Art Unit: 3635

REMARKS

ATTACHED APPENDIX CLEAN VERSIONS OF DRAWINGS, SPECIFICATION TEXT AND CLAIMS

A corrected drawing for FIG. 5 is attached showing numeral 18 as described in the specification on page 6, line 24.

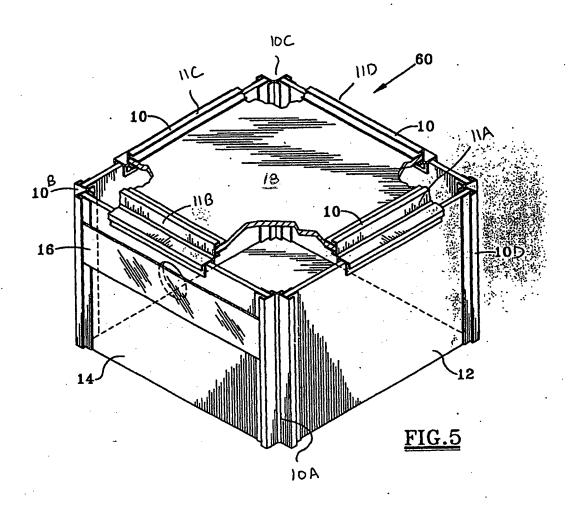
The drawings were objected to under 37 CFR 1.83(a) because they failed to show numeral 18 as described in the specification on page 6, line 24.

A corrected drawing is attached showing numeral 18 as described in the specification on page 6, line 24.
